Olin Corporation

Memorandum

Subject: Response to USEPA Memo dated Nov. 29, 2018 – Resolution of CSM

**Figure G.** The specific conductivity trend in MP-2 ports is consistent with the conductance in adjacent well GW-42D.

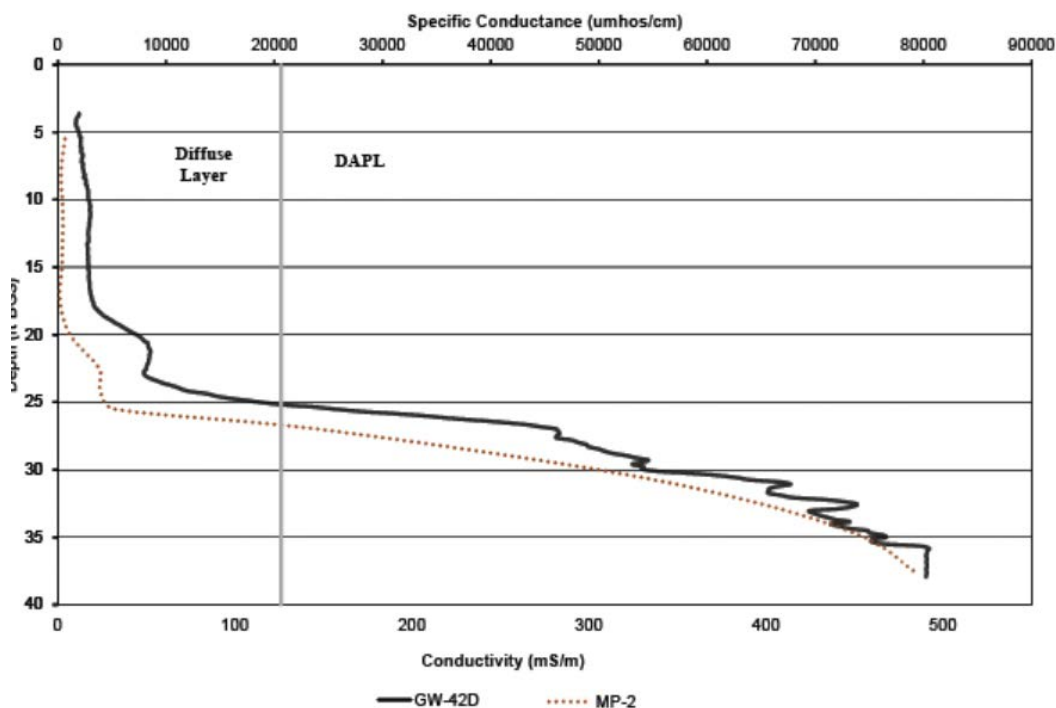
**Item B:** Soil sampling to evaluate concentrations of DAPL contaminants and the presence of precipitates that may cause false positives for induction logging. A method which can provide continuous soil profiles through depth intervals of interest is needed.

**Olin Response to USEPA Recommendation #4 (1<sup>st</sup> Paragraph):** Olin concurs that a down-well specific conductivity profile is appropriate and will provide pertinent and useful information (see **Figure G** showing the excellent agreement between the specific conductivity in MP-2 versus the conductance profile in adjacent GW-42D).

**Olin Response to USEPA Recommendation #4 (2<sup>nd</sup> Paragraph, Item B):** The induction log in GW-42D from 2003 is in good agreement with the specific conductivity profile in adjacent MP-2 (within ~20 ft) collected at the same time. There is no evidence of bias due to precipitates (**Figure G**).
